**Final Environmental Impact Statement
Dollar General Retail Store
240 & 248 Buffalo Street, Gowanda, New York**

Lead Agency:
Village of Gowanda Board of Trustees
27 East Main Street
Gowanda, New York 14070

Prepared by:
Fisher Associates
325 Delaware Avenue, Suite 200
Buffalo, New York 14202
(716) 858-1234

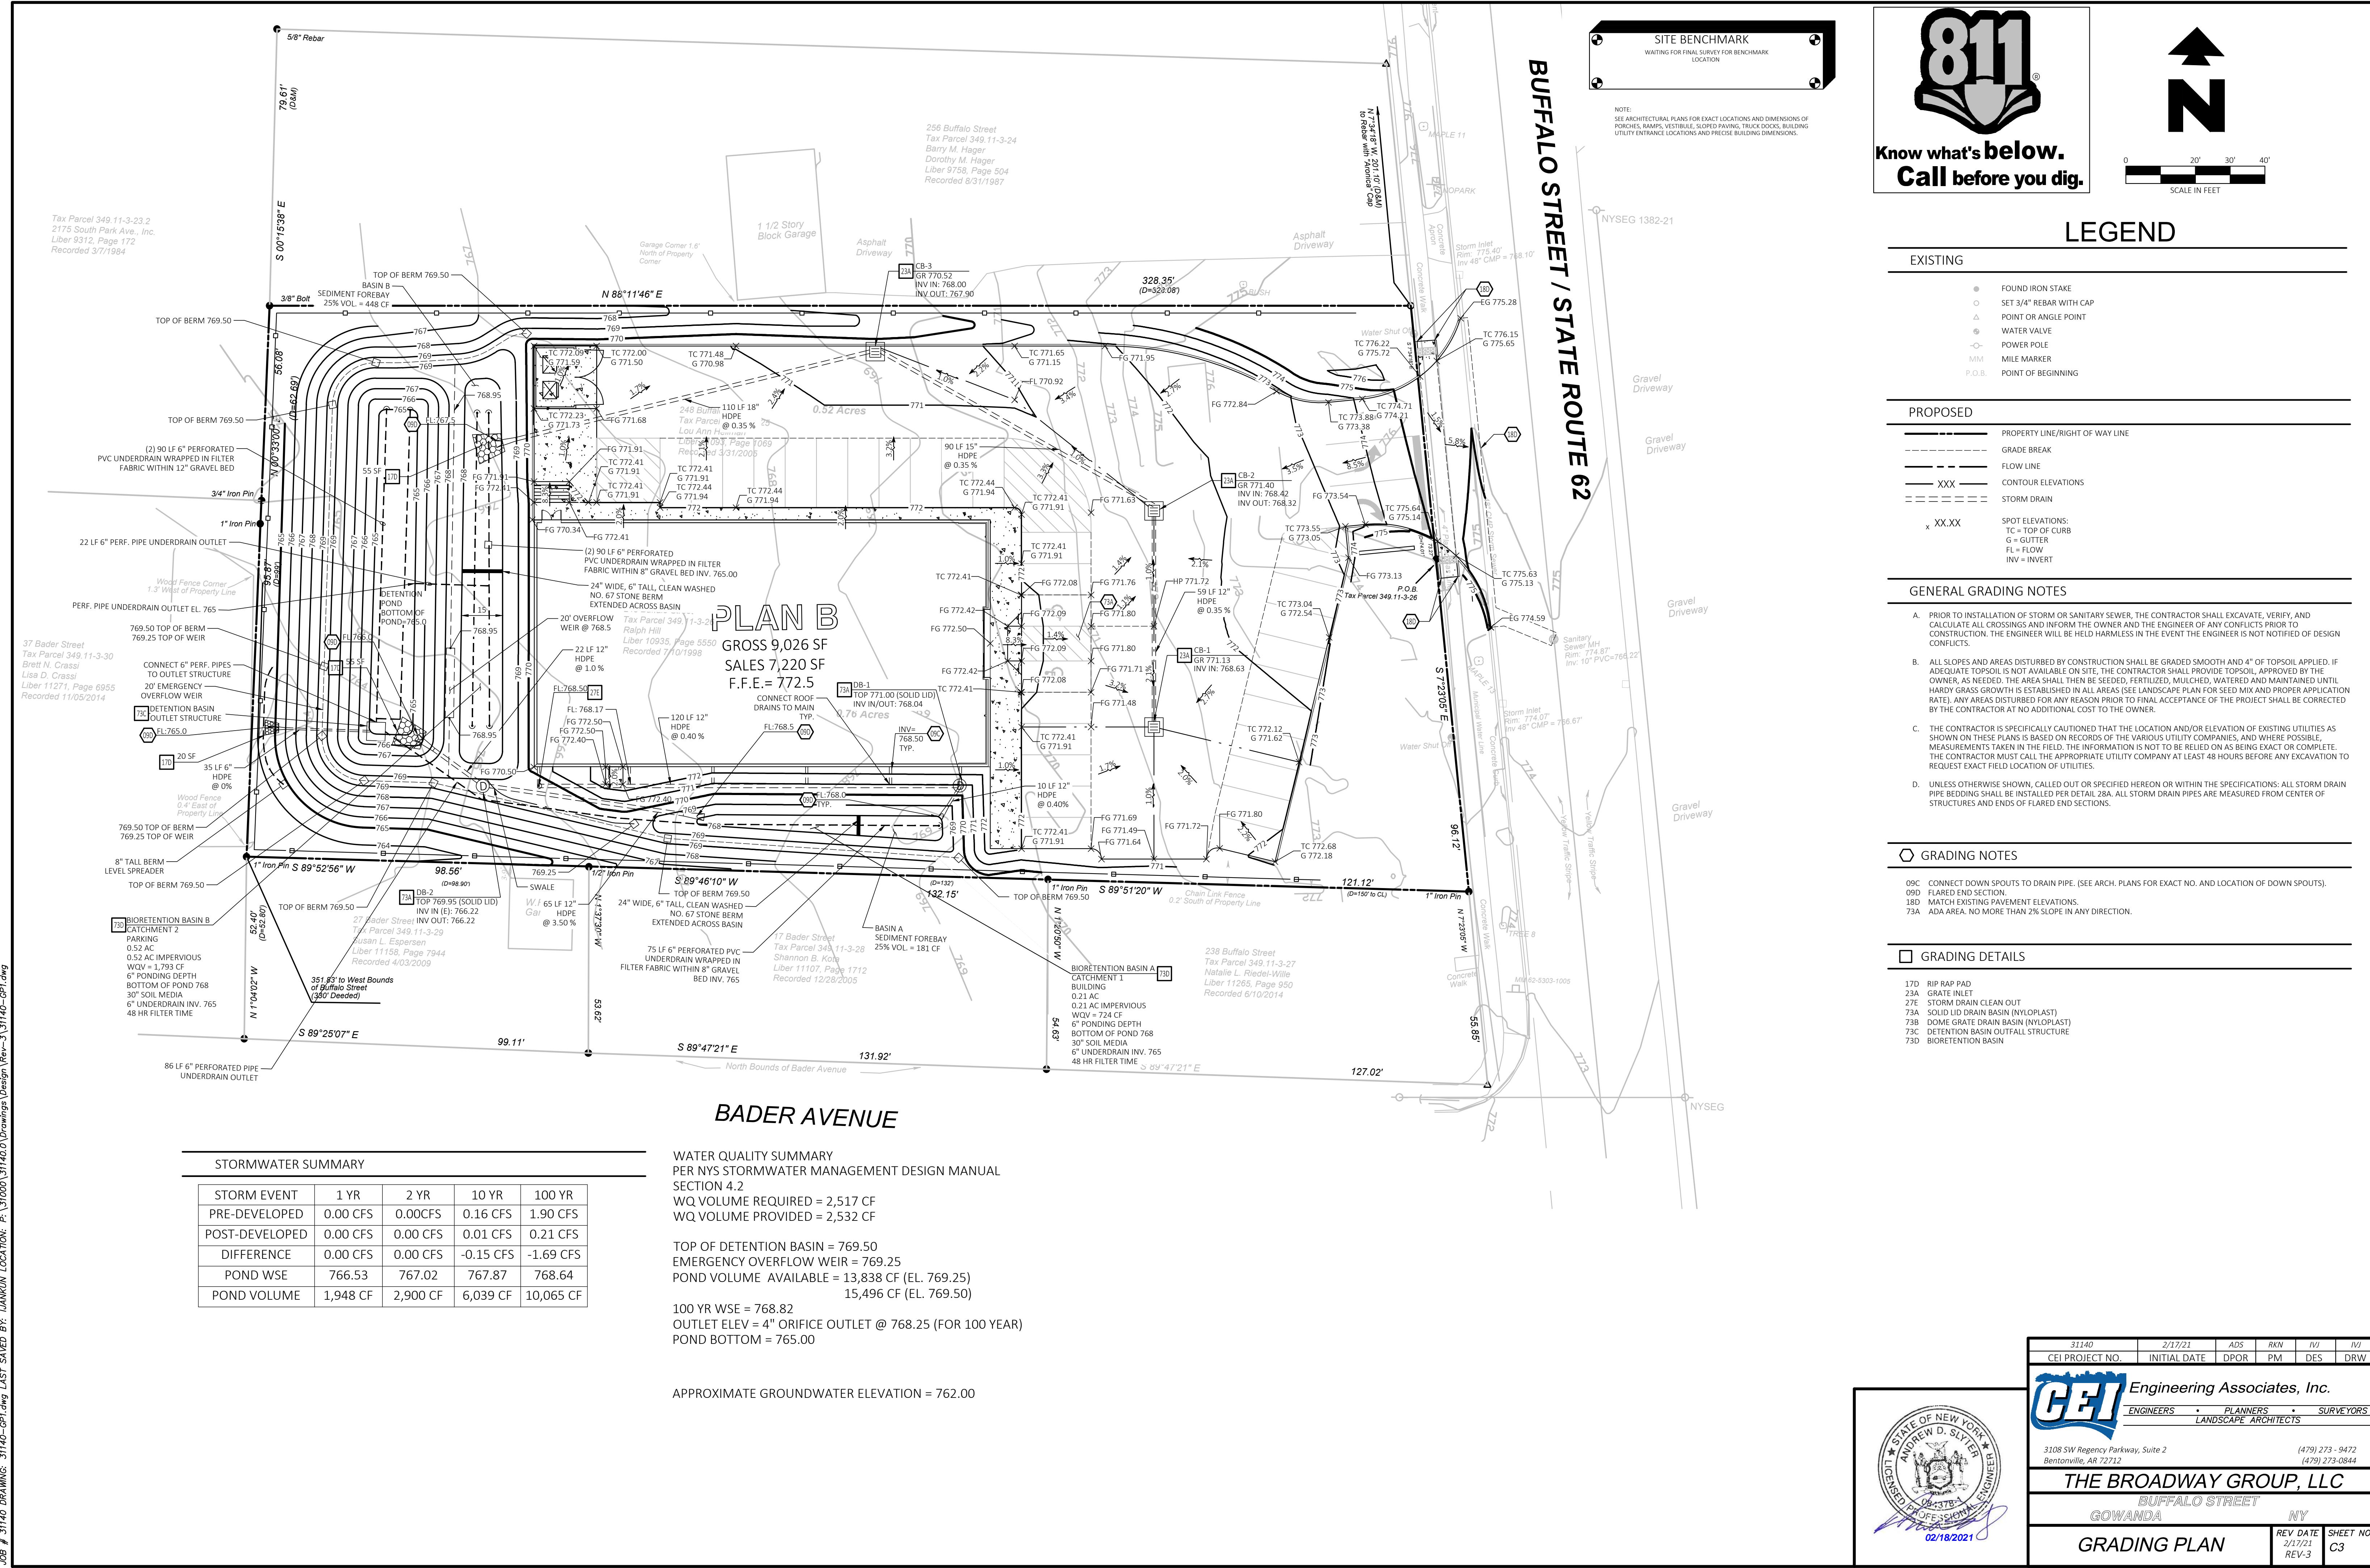
- 2) The drainage details for the detention basin outfall structure and the bioretention basin have now been provided in Appendix K (dated 7/15/20). The previous version of the DEIS had drawings from 6/16/20 which did not include this information. Upon review of these details, the following elements of the design do not meet NYS requirements for stormwater treatment.
 - a. The depth of bioretention soils provided is insufficient. 30" of soil depth must be provided at a minimum (see figure 6.19 of the NYS Stormwater Design Manual) versus the 22" shown in the detail on Sheet C8 of Appendix K.

Response: The depth of bioretention soils has been revised to 30" both on the Grading Plan, Sheet C3 and in the bioretention basin detail on the Detail Sheet, Sheet C8, of Appendix K.

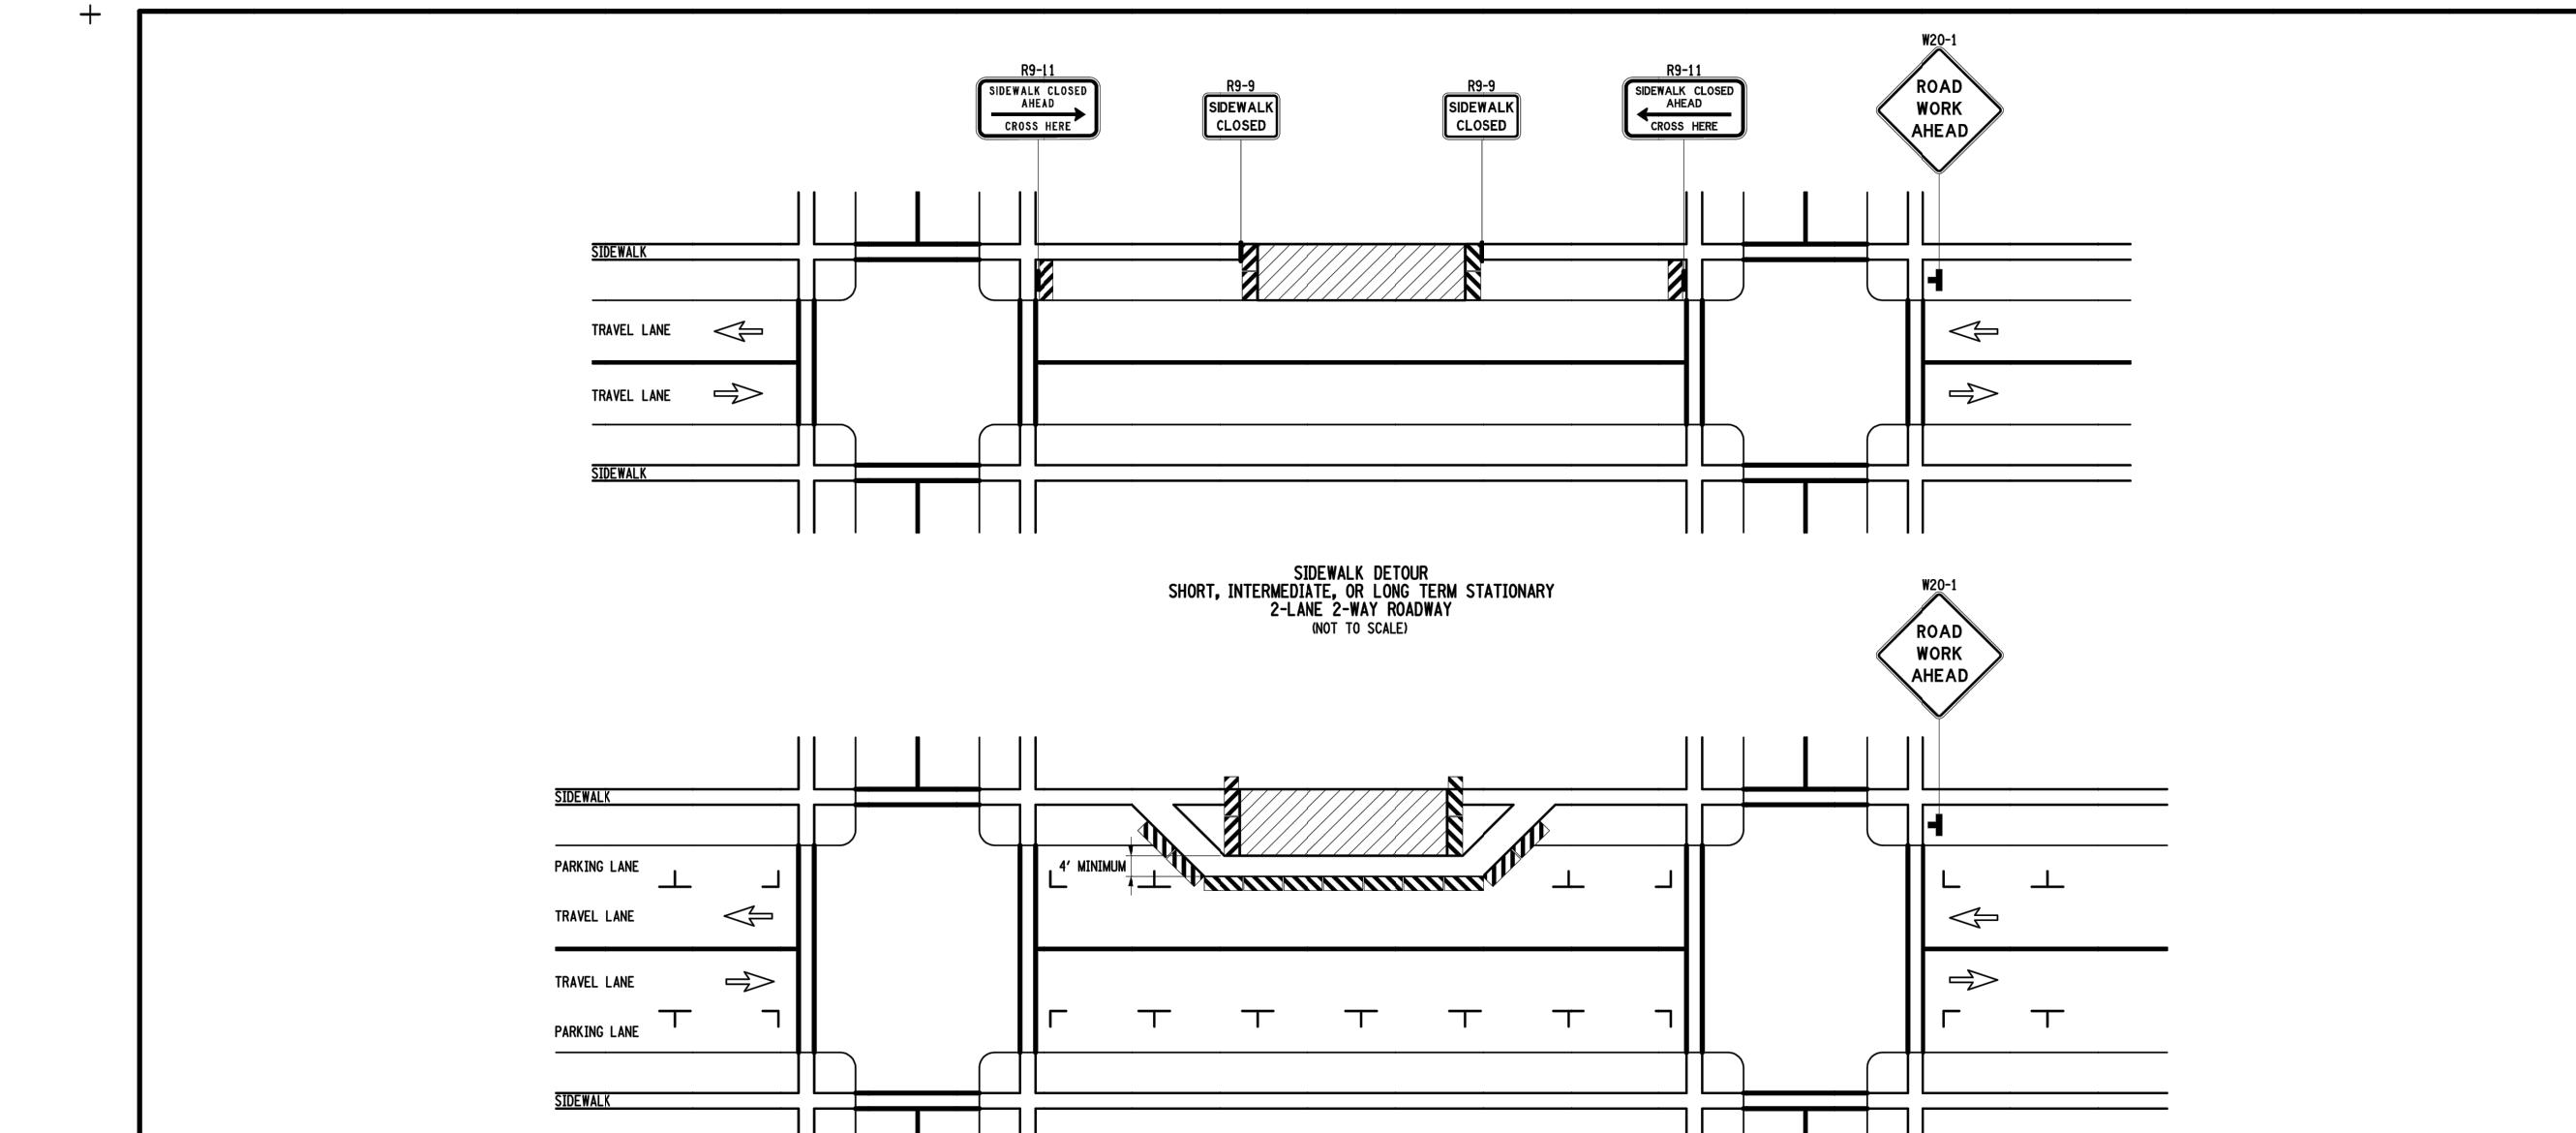
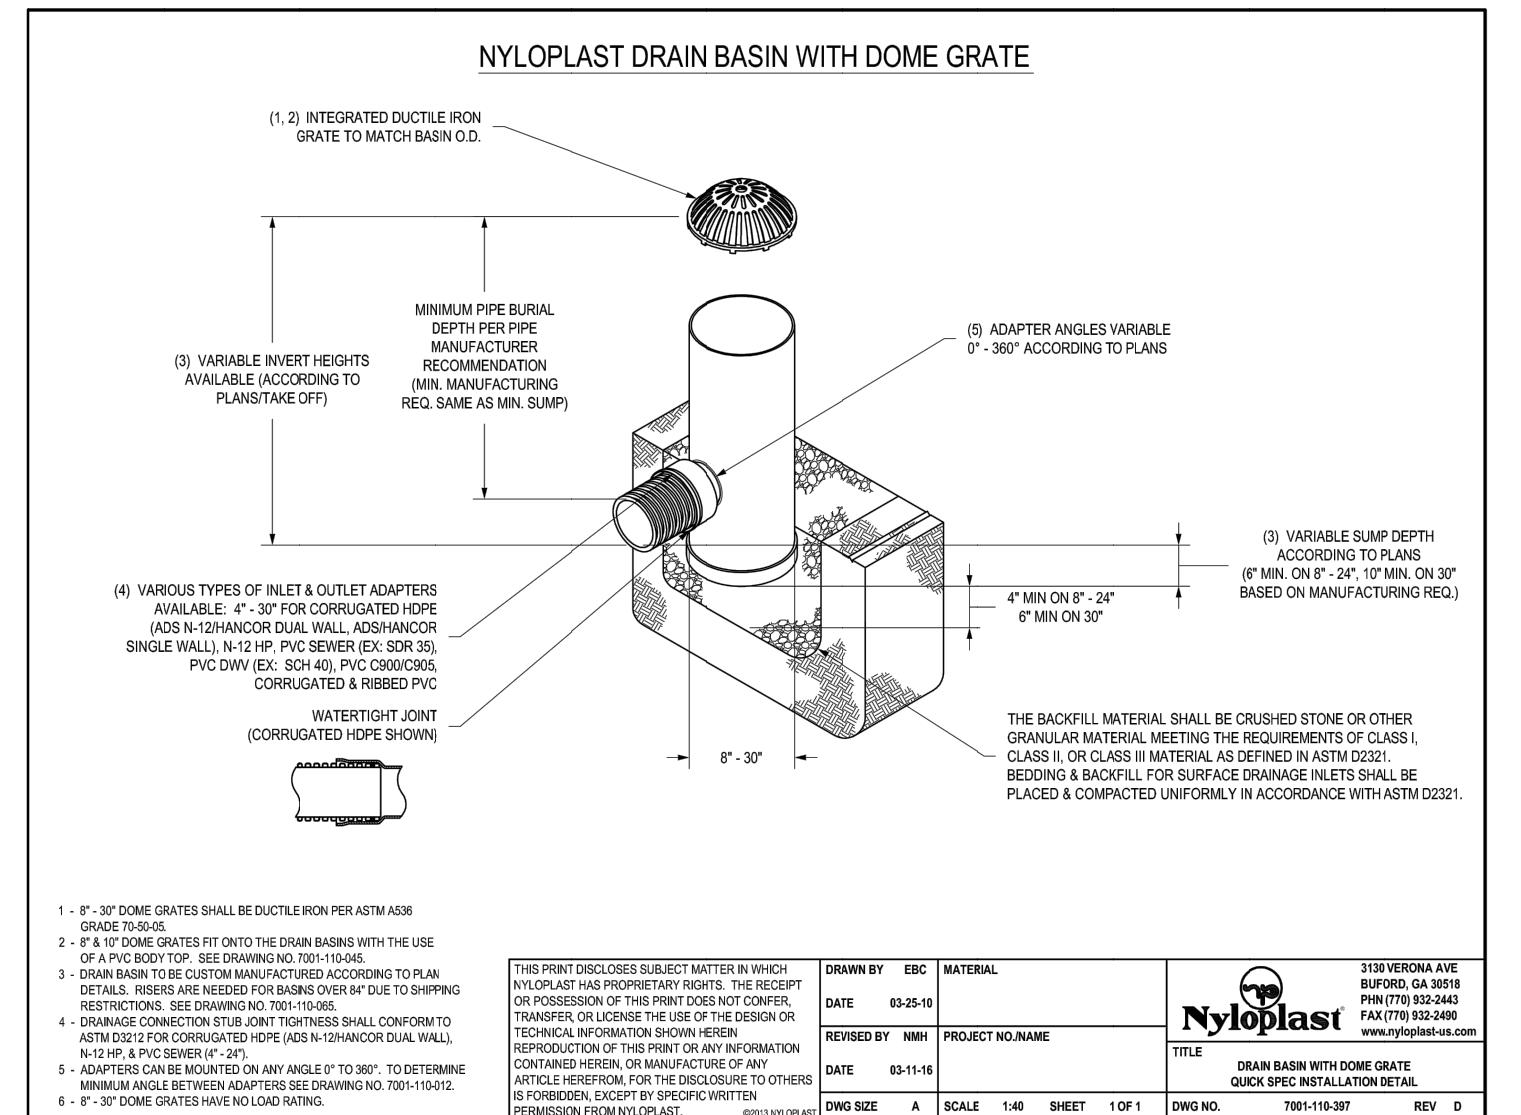
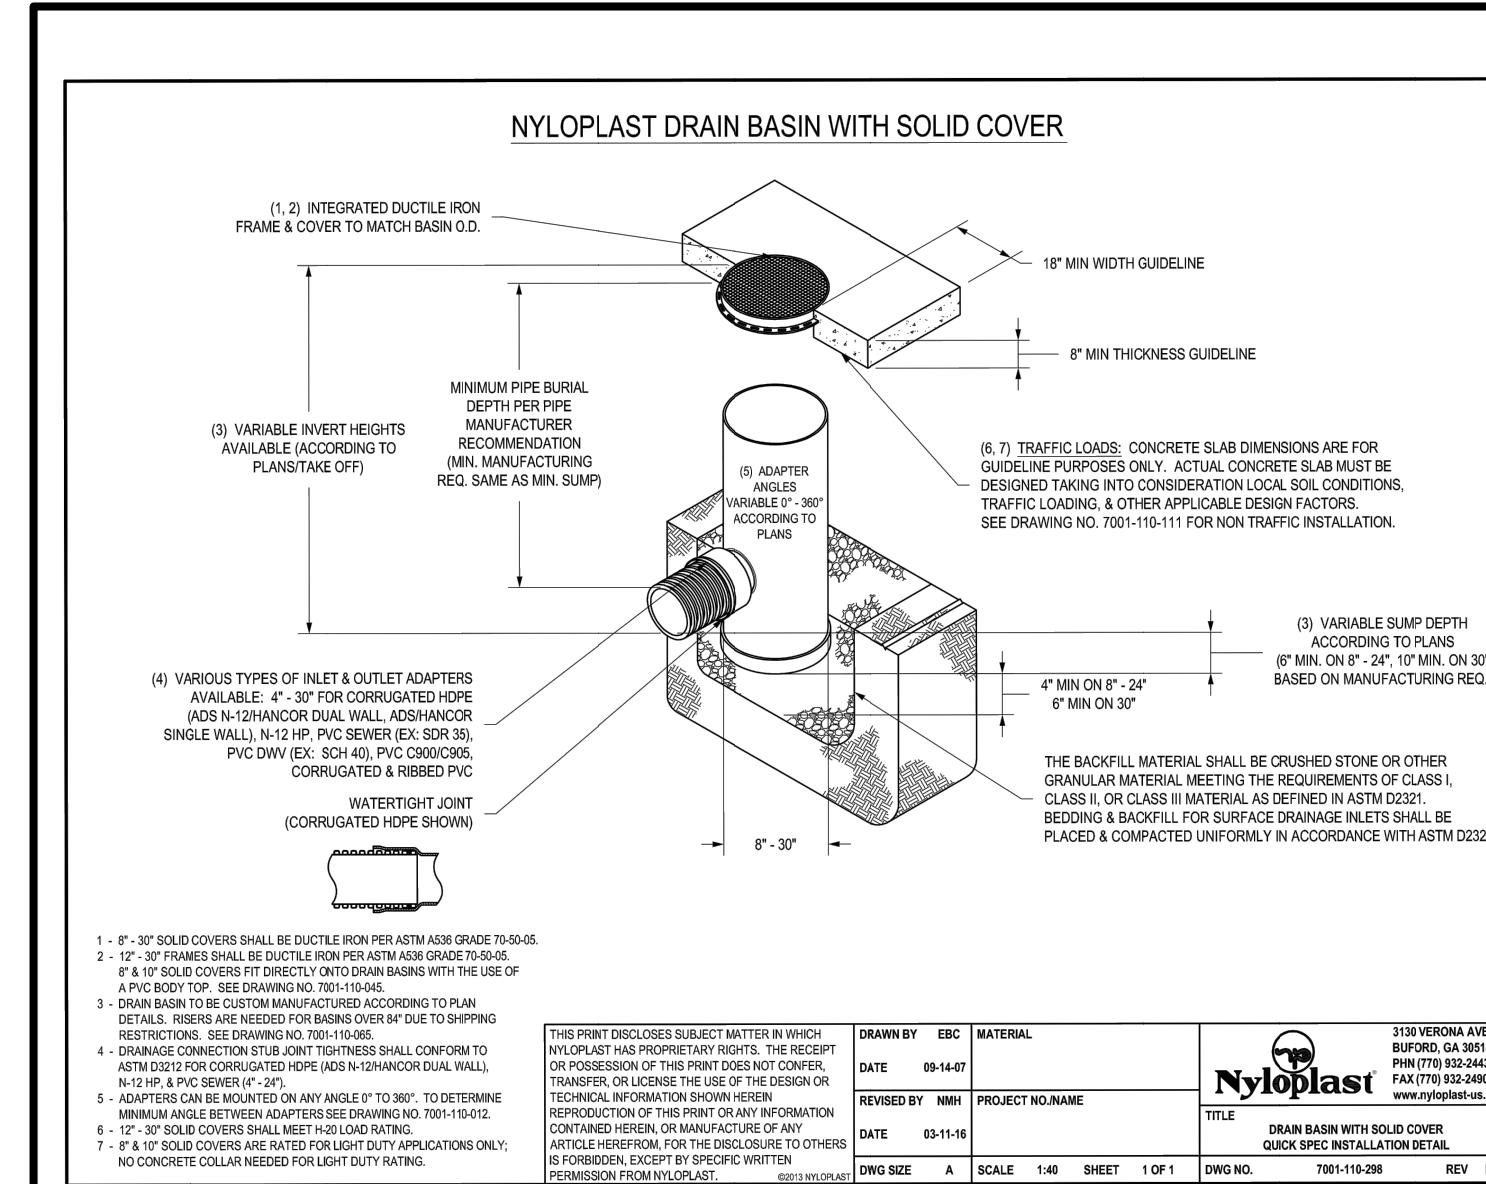
- 2) The sediment forebay for Bioretention Basin A is not acceptable. The forebay is located at the west edge of the bioretention basin, while all the inflows to the basin are located at the east side. The forebay will not treat the inflows before they enter the main portion of the bioretention area.

Response: The sediment forebay for bioretention basin A has been revised to be located on the east end of the basin and the inflow from the roof drains, which connect to the basin, have been revised to enter the basin on the east end to enter the forebay and be treated prior to entering the main portion of the bioretention basin.
